## ADDENDUM 4

DATE: November 30, 2016  
 PROJECT: MSB First Floor Infill LRC 3 & 4  
 RFP NO: 744-R1705  
 OWNER: The University of Texas Health Science Center at Houston  
 TO: Prospective Proposers

This Addendum forms part of and modifies Proposal Documents dated, October 19, 2016, with amendments and additions noted below.

### Reflected Ceiling Plans - Ground Level

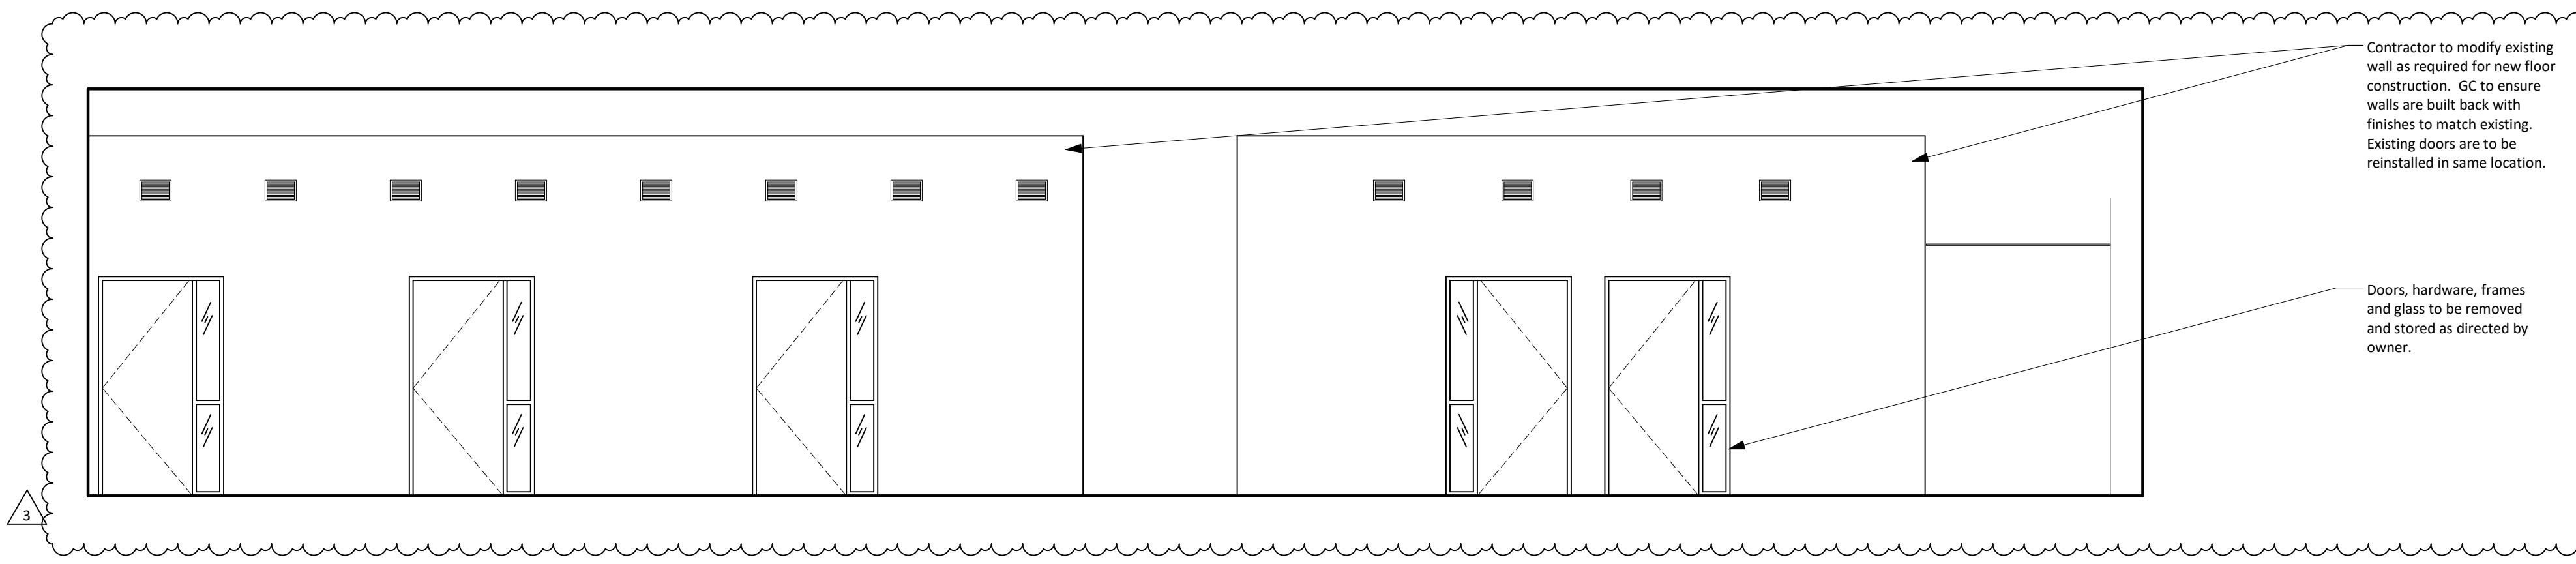
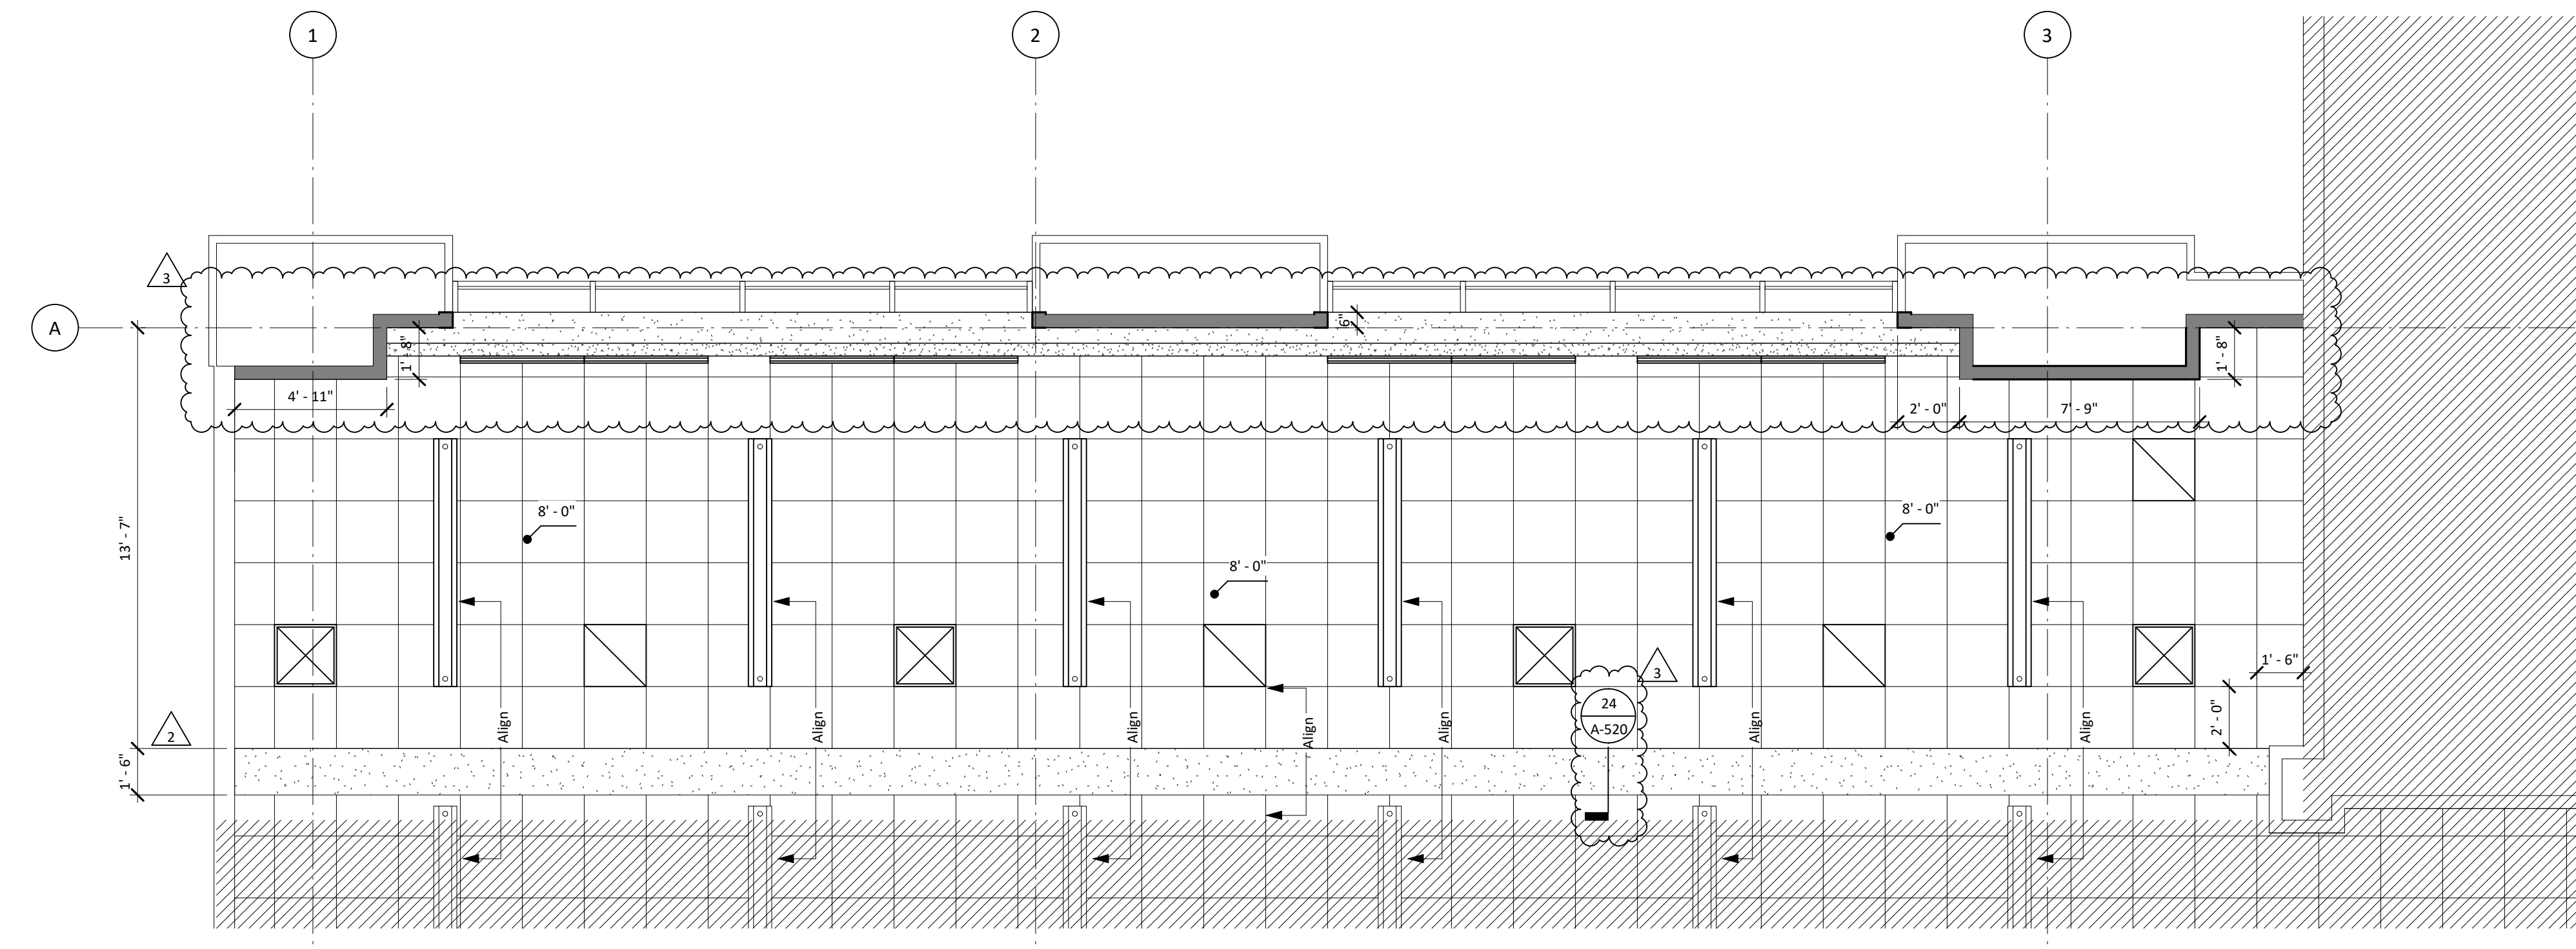
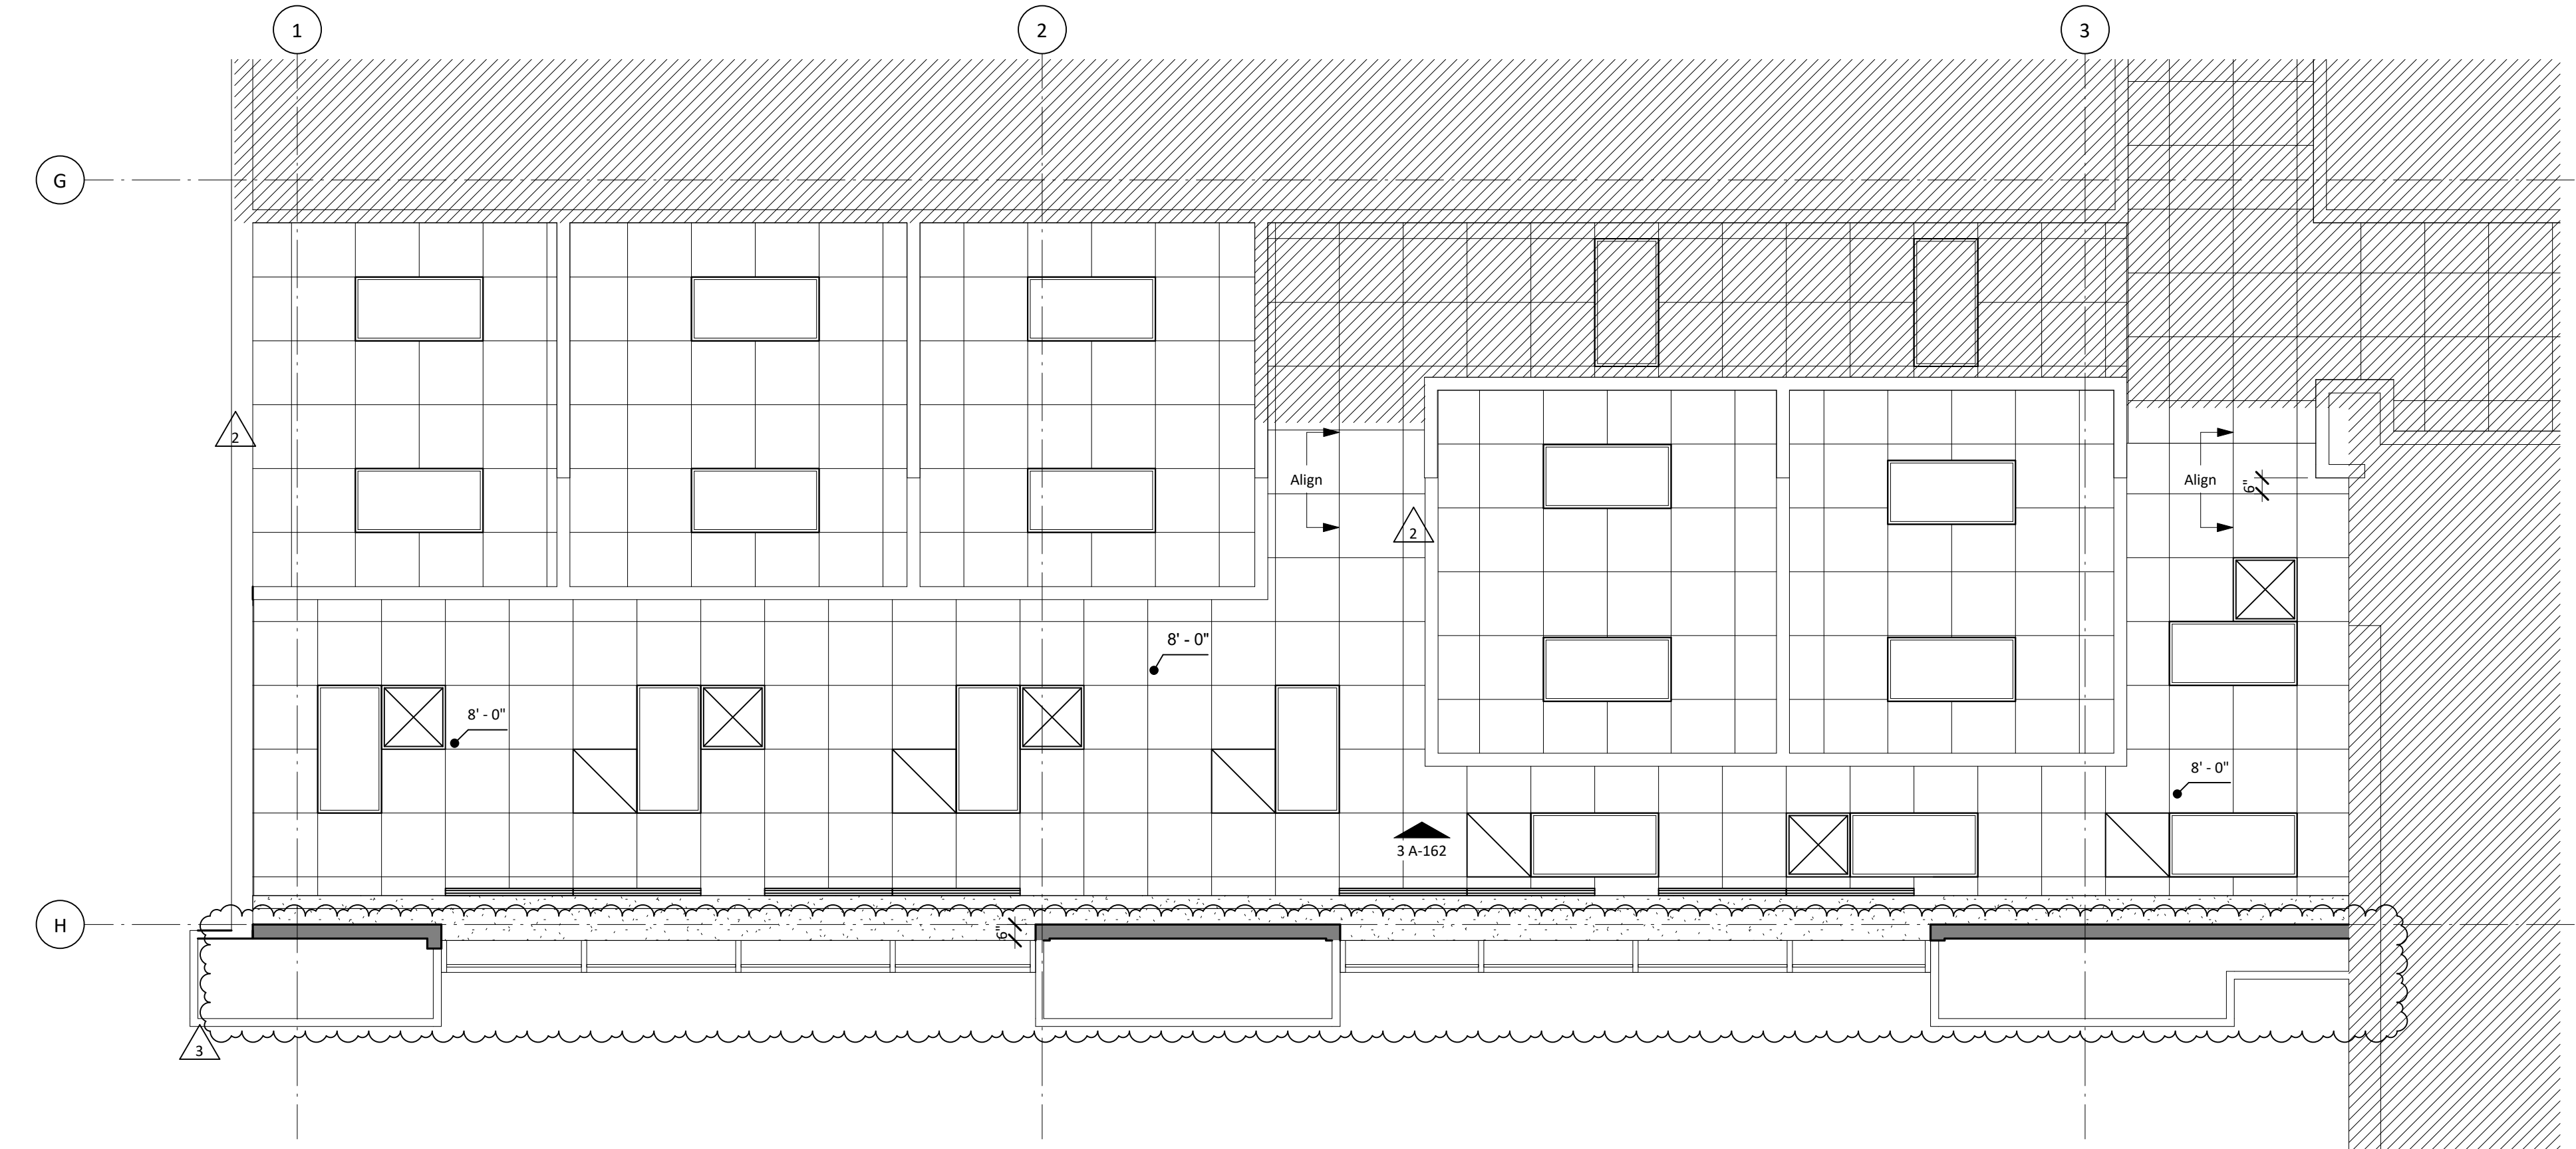
3. Drawing A-161 Detail 1 completely demolishes the ground floor group study rooms and is not shown to be rebuilt after completion of construction. Is this the design intent? If not, please provide a renovation plan detailing the build back.  
**Walls being demolished on the ground floor are to be built back up; ceiling grid removed at ground level needs to be reinstalled, doors, frame and hardware are to be removed and reinstalled. All floor finishes are to be preserved; if damaged or removed GC to reinstall to match the existing finishes. Additional information provided in Addendum 4 drawings below.**
